**CONCEPT DEVELOPMENT PLAN
BOONE COUNTY PLANNING COMMISSION**

2. Name of Project: JAGGERS
3. Location of Project: Houston Road and Turfway Road (Parcel ID 061.00-11-015.00)
4. Total Acreage of Project: 1.55
5. Current Zoning of Property: C-2/PD/CD/HDO Zoning District
6. Date of previous zoning map amendment or Approved Concept Development Plan (if applicable):
NA

Request of **GreenbergFarrow, per Brandon Goldberg (applicant)** for **Turfway Commons Trust (owner)** for a Change in an Approved Concept Development Plan in a Commercial Two/Planned Development/Houston-Donaldson Study Corridor Overlay (C-2/PD/HDO) district for an approximate 1.55 acre area located along the northwest side of Houston Road, between 5001 Houston Road and 4953 Houston Road, and being part of the properties at 4999 Houston Road and 4951-4997 Houston Road, Florence, Kentucky. The request is for a Change in an Approved Concept Development Plan for an eating and drinking establishment with a drive-through.

SITE PLAN

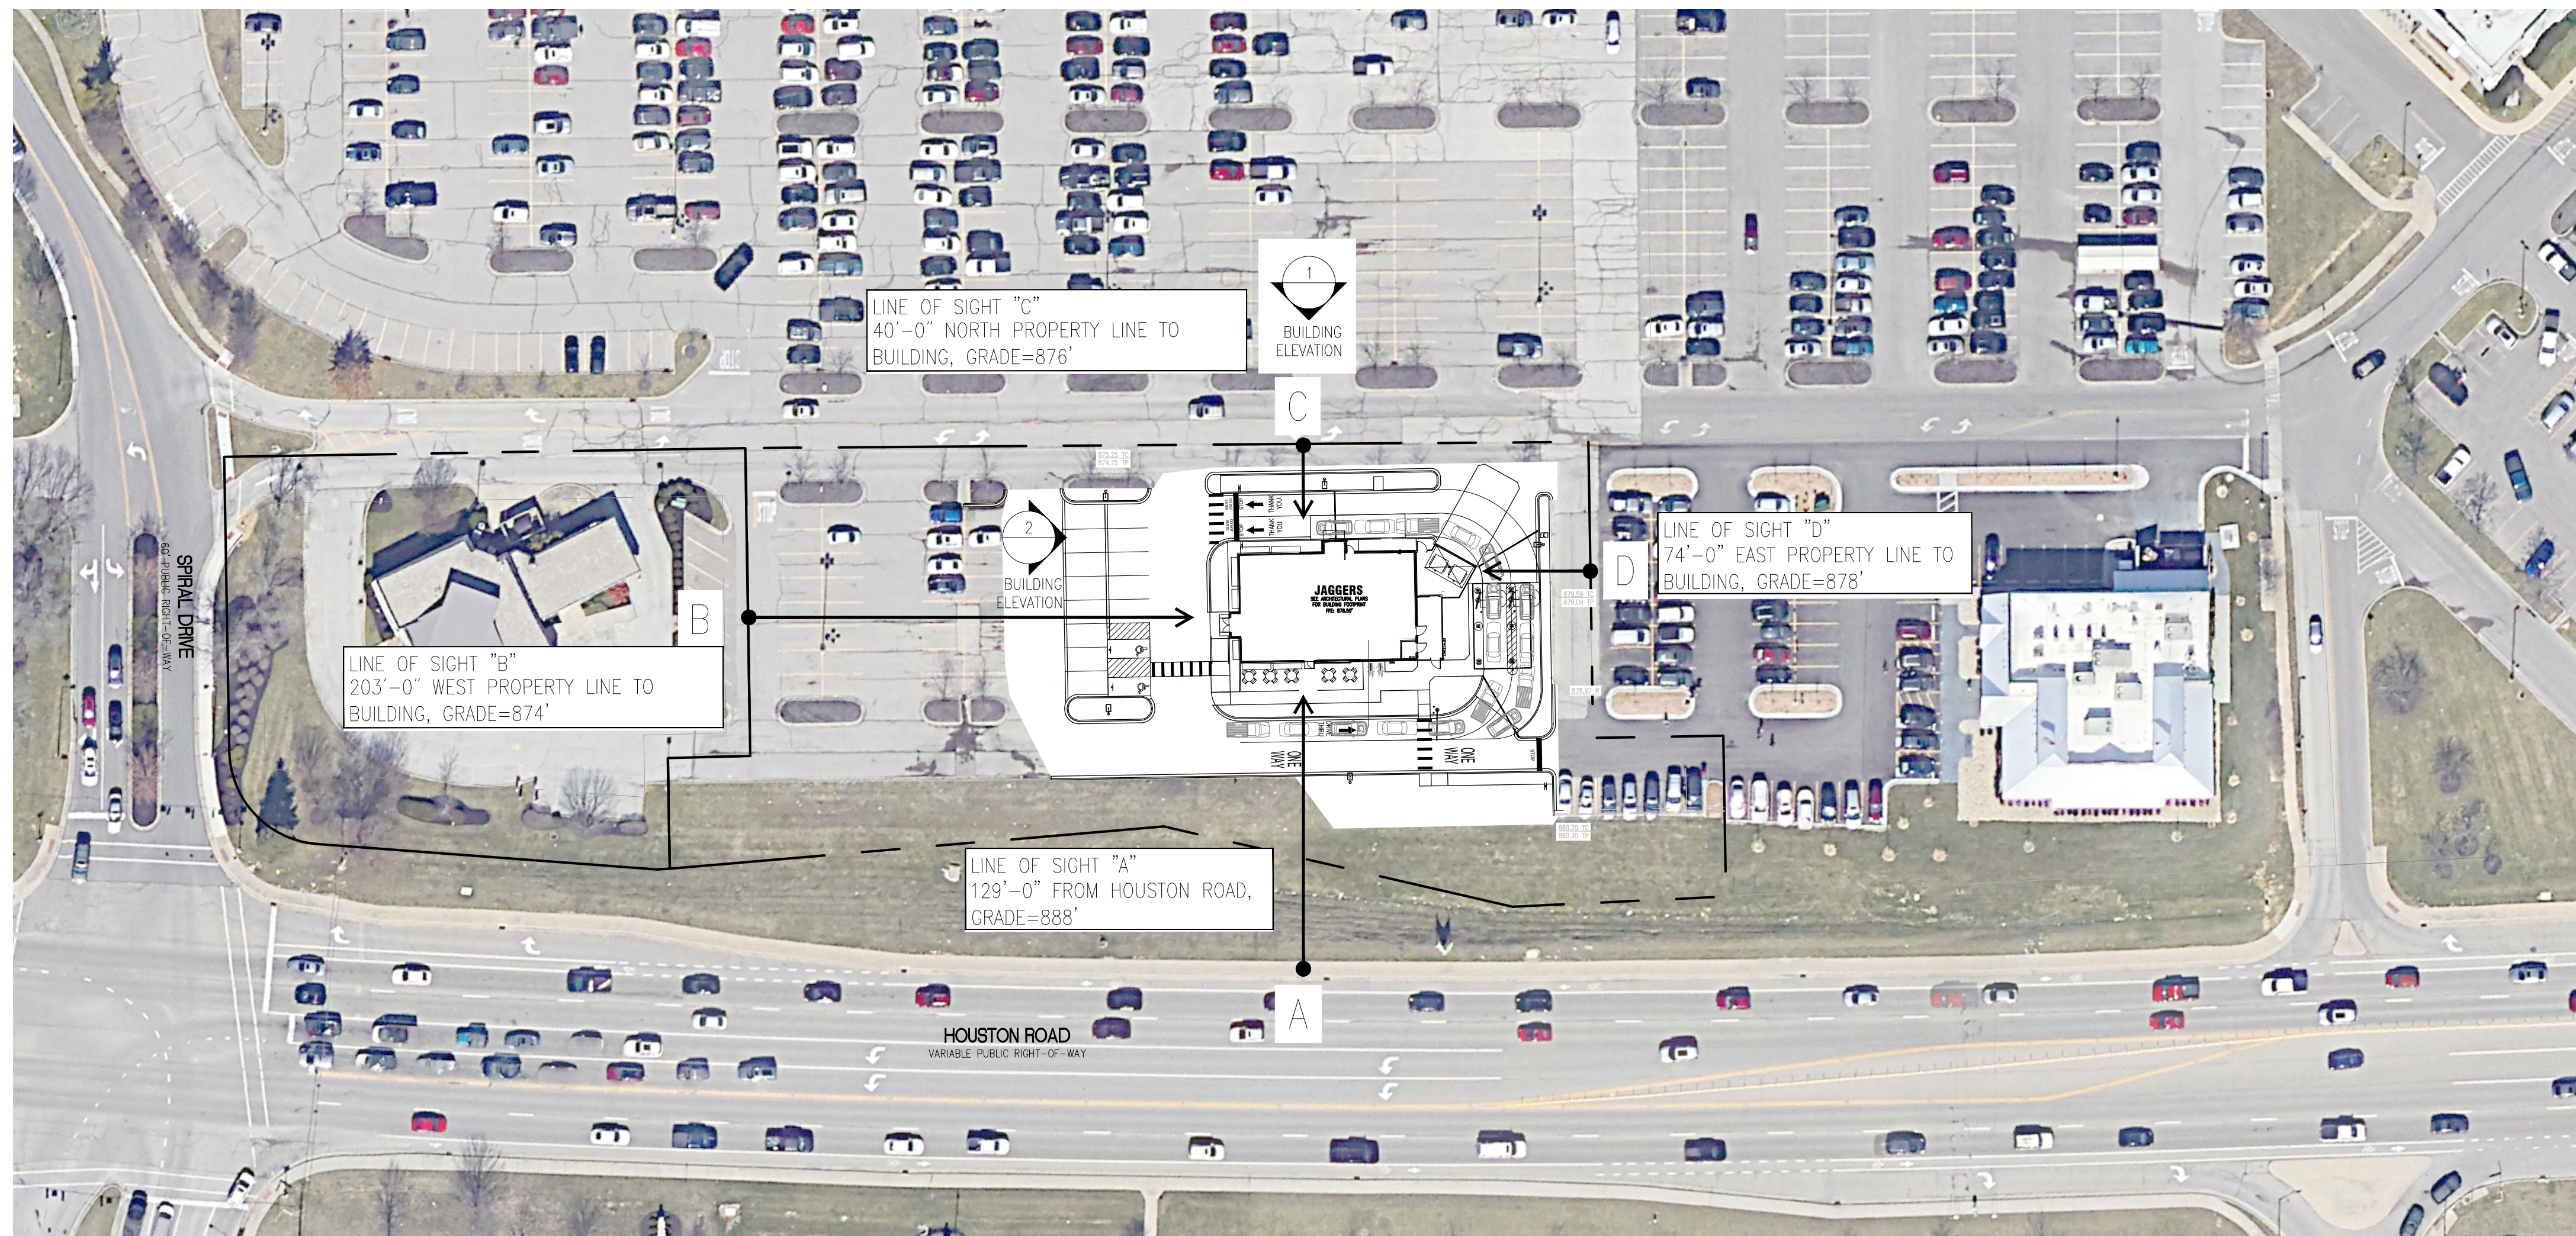
The submitted plan indicates that there will be a canopy located to the rear of the building that will not be attached to the principal structure. Additionally, no plans have been submitted to determine if the canopy will match the principal structure.

The submitted plan does not provide the required stacking spaces for eating and drinking establishments.

The submitted plan indicates that the driveway between the building and Houston Road will have a width of fourteen (14) feet. While the plan does not indicate that this will be a two-way driveway, the design necessitates to be a two-way driveway.

REAR (EAST) ELEVATION

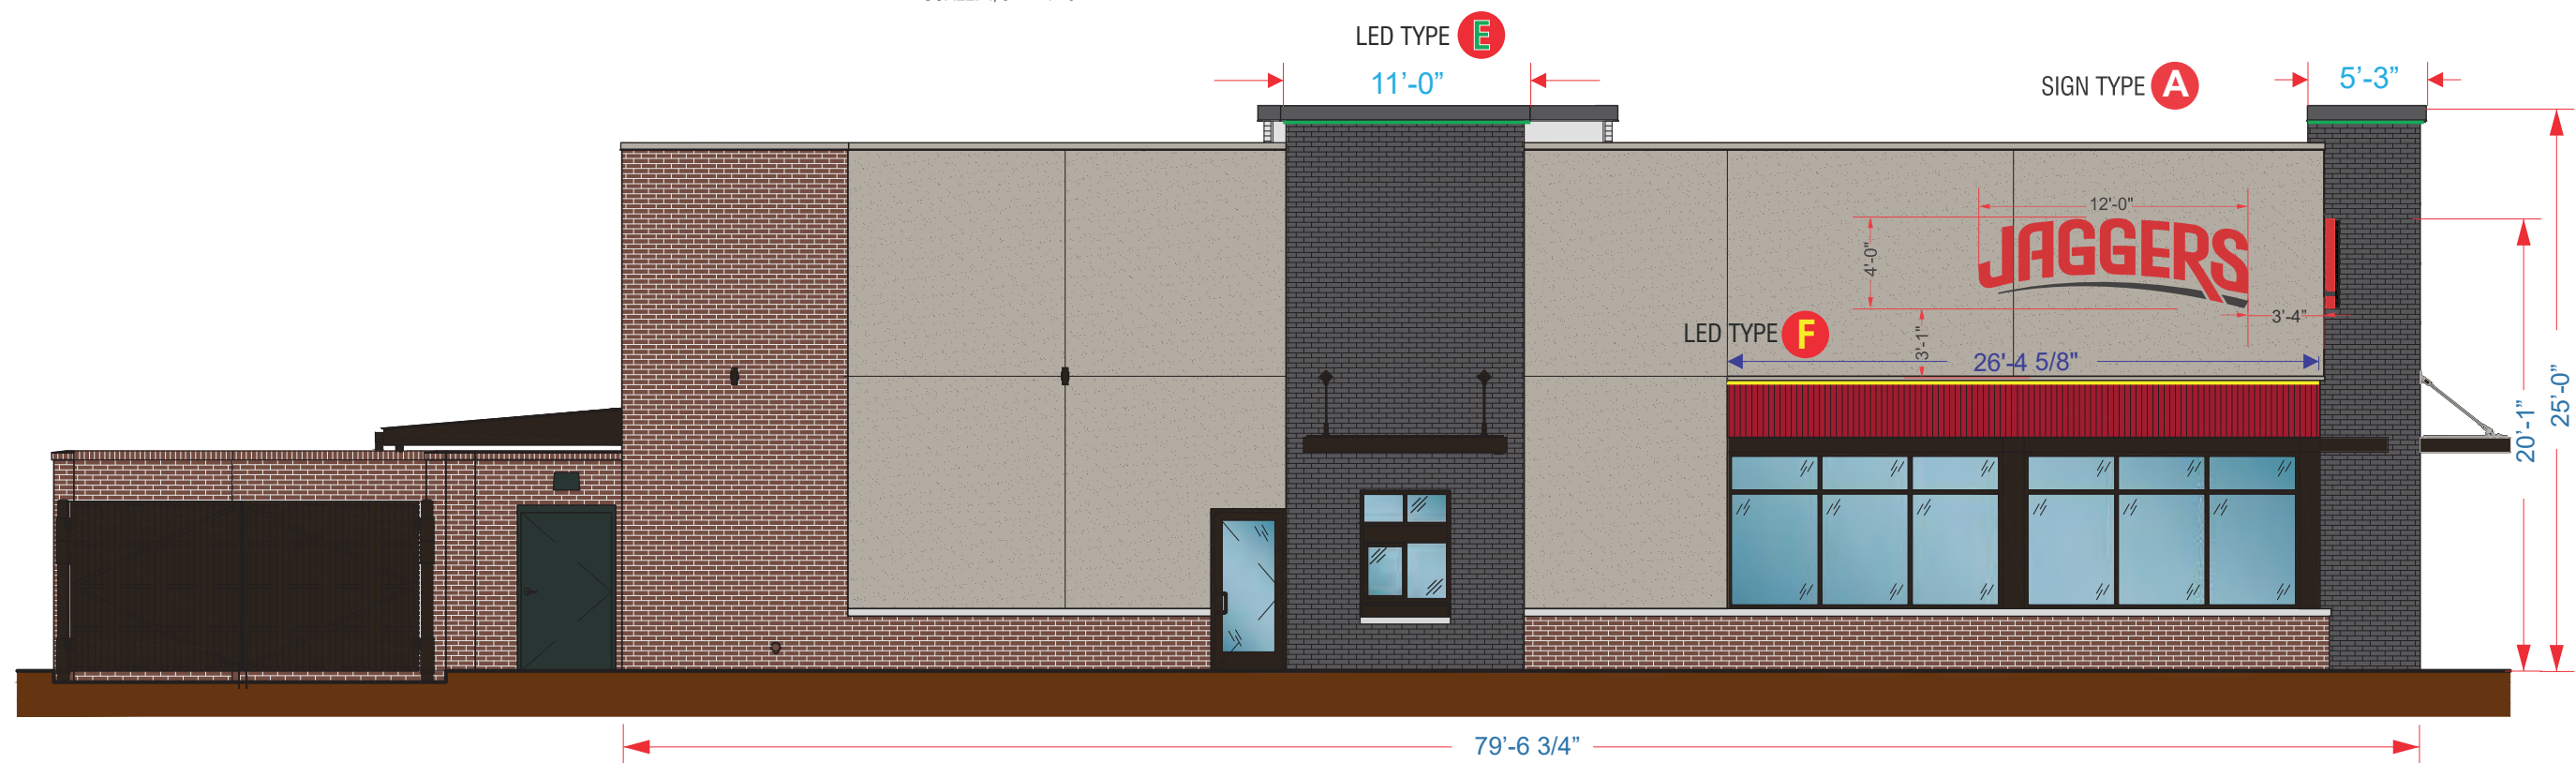
The submitted plan indicates that the rear (east) building façade will be largely blank, with no windows or openings. This building elevation will be facing the existing Texas Roadhouse restaurant and will be visible by drivers travelling west on Houston Road.
